The changes shown in PL-2, ECN # 4 are of minor importance. A few will apply also to the PL-1.

PREPARED	NAME L. Pazmany	4-30-74	PAZMANY AIRCRAFT CORPORATION — SAN DIEGO — CALIFORNIA —	MODEL NO.	PL-1 PL-2
			OPERATING LIMITATIONS

PREPARED	NAME L. Pazmany	3-18-74	PAZMANY AIRCRAFT CORPORATION — SAN DIEGO — CALIFORNIA —	MODEL NO.	PL-2
CHECKED			ENGINEERING CHANGE NOTICE #4	REPORT NO.	
APPROVED				PAGE NO.	1

DWG 2-10-011 - SHT.1 -

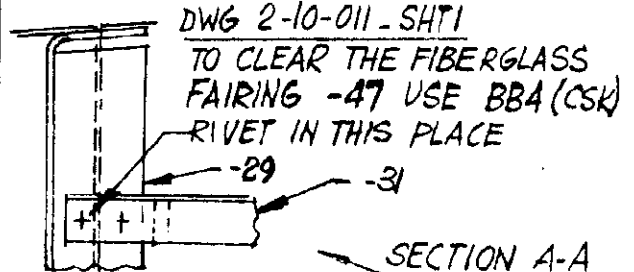
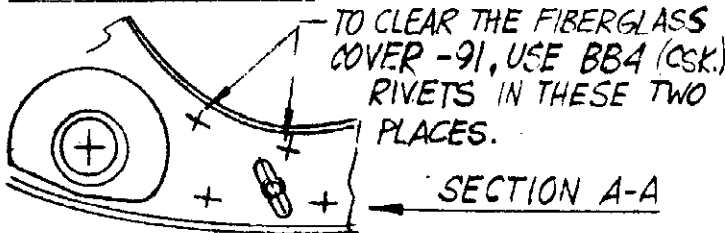
DWG. 2-10-011 SHT.1 - DURING A STATIC TEST IT WAS FOUND THAT THE PLUNGER FOR THE FLAP CONTROL LEVER (2-50-003-39) WILL NOT TAKE THE MAXIMUM LOAD. THE PLUNGER THICKNESS SHOULD BE DOUBLED, TO .250 AND THE CORRESPONDING SLOTS IN 2-10-011-37 SHOULD BE INCREASED TO .250. CORRESPONDENTLY, THE SLOTS IN THE FLAP LEVER 2-50-003 -23, -25 AND -27 SHOULD ALSO BE INCREASED TO .250 WIDE.

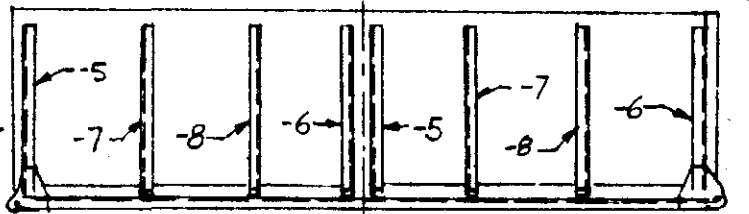
DWG 2-10-009 - THE CALL-OUT FOR ALL RIBS IN THE FLAP CENTER SECTION IS REVERSED. CHANGE THE DASH NUMBERS FOR ALL RIBS 2-10-005 AS SHOWN

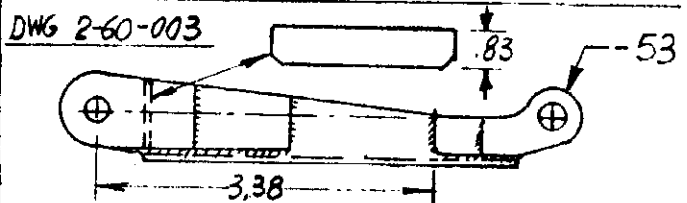
CHANGE SHAPE OF FLANGE AS SHOWN TO PROVIDE
FOR A BEARING SURFACE AGAINST STOP -41 WHEN
GEAR IS FULLY EXTENDED.
